SUBJECT: PUDSP-21-002 – Skyline at Lorson Ranch (with EGP)
First Submittal

Transportation / Traffic Impact Study

Skyline at Lorson Ranch Traffic Impact Analysis (LSC #204250) January 21, 2021

LSC Responses to TIS Redline Comments

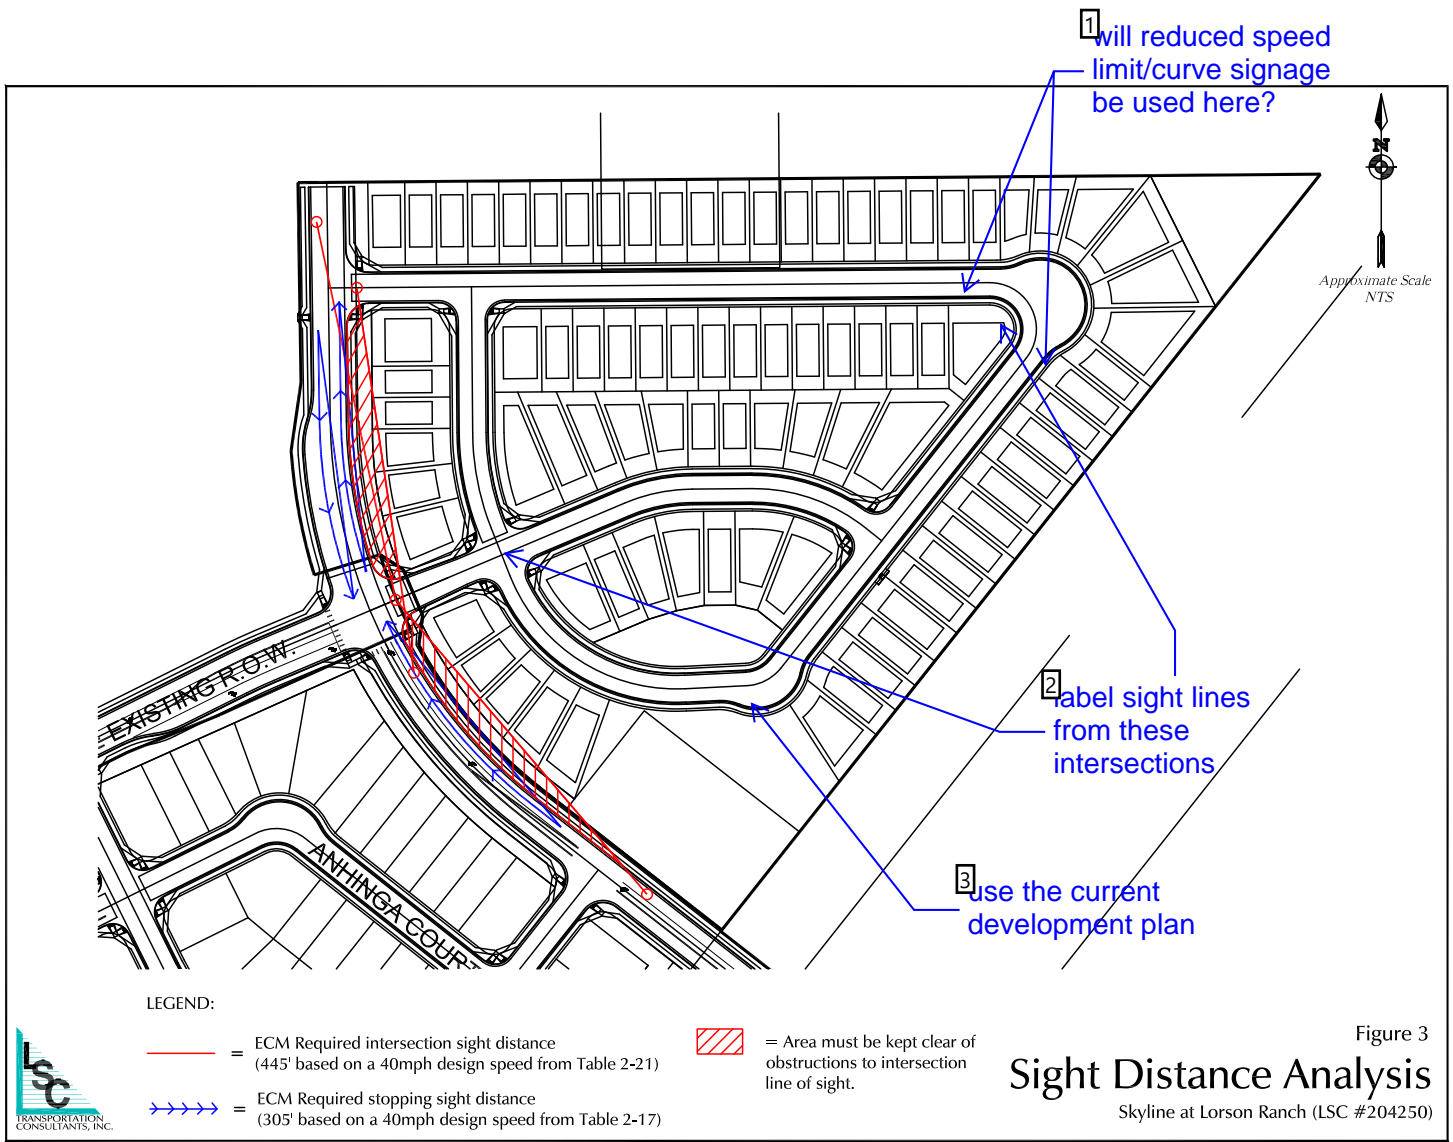
[will reduced speed limit/curve signage be used here?](#)

[label sight lines from these intersections](#)

[use the current development plan](#)

LSC Response: No, as the centerline radius meets ECM criteria for an Urban Local knuckle - thus the design speed is the same. The sight distance is addressed in the updated TIS report.

LSC Response: Added and addressed in the updated TIS report as requested. Also, sight distance easements have been added to the plan.

LSC Response: Updated as requested.

**Appendix Table 1
Area Traffic Impact Studies by LSC
Skyline at Lorson Ranch**

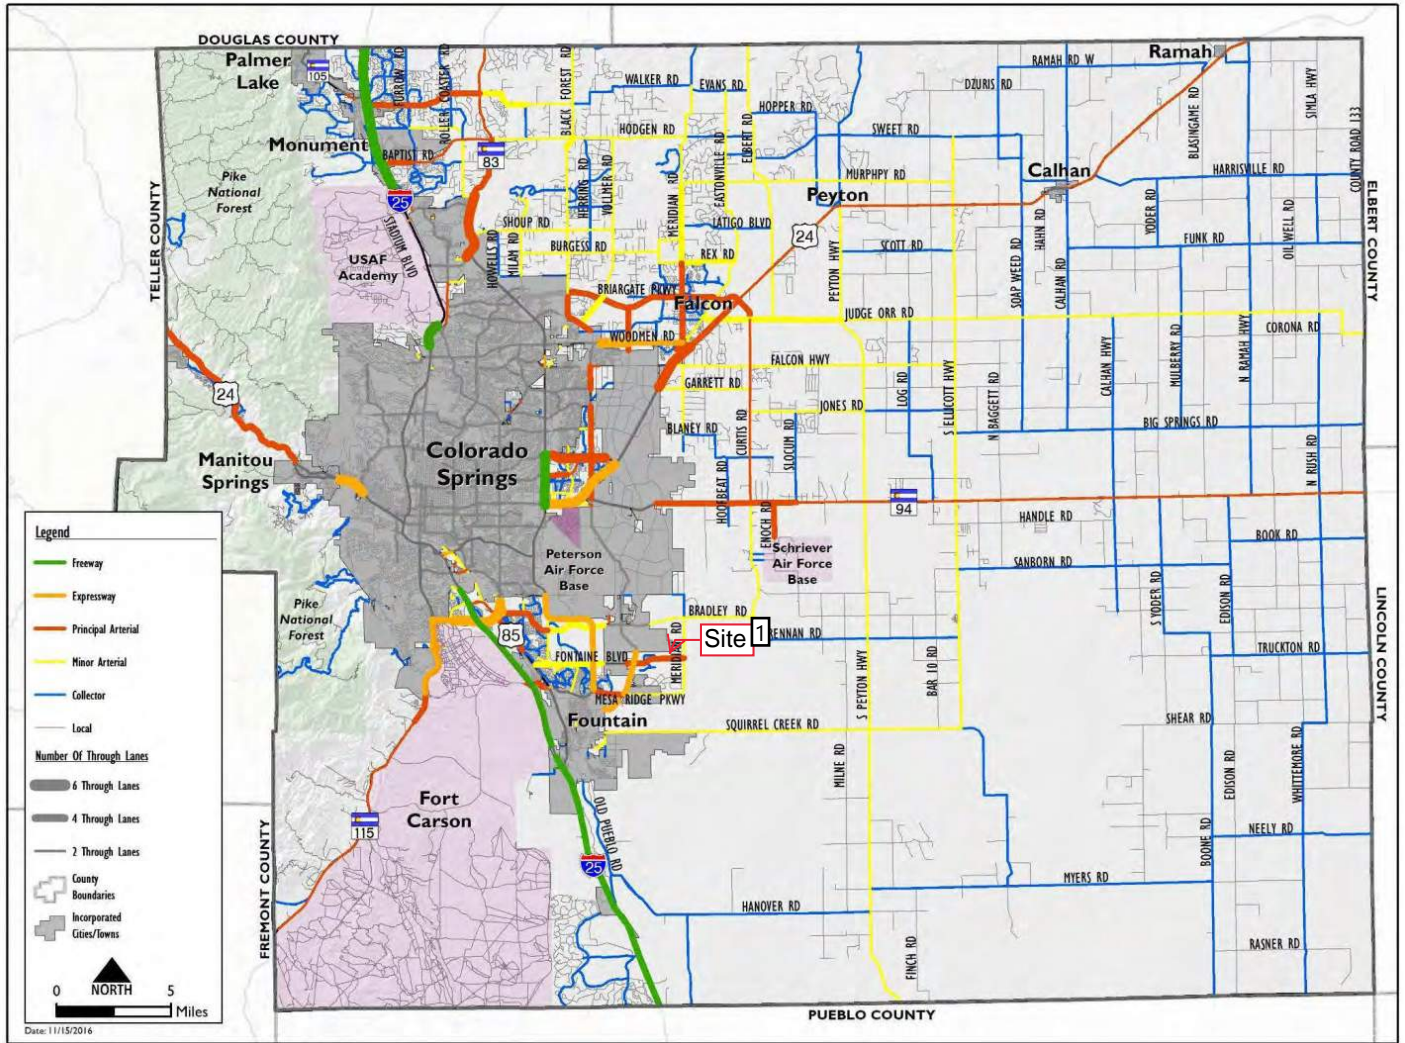
add The Hills
Memorandum
(TBD)

[add The Hills Memorandum \(TBD\)](#)

LSC Response: Added as requested.
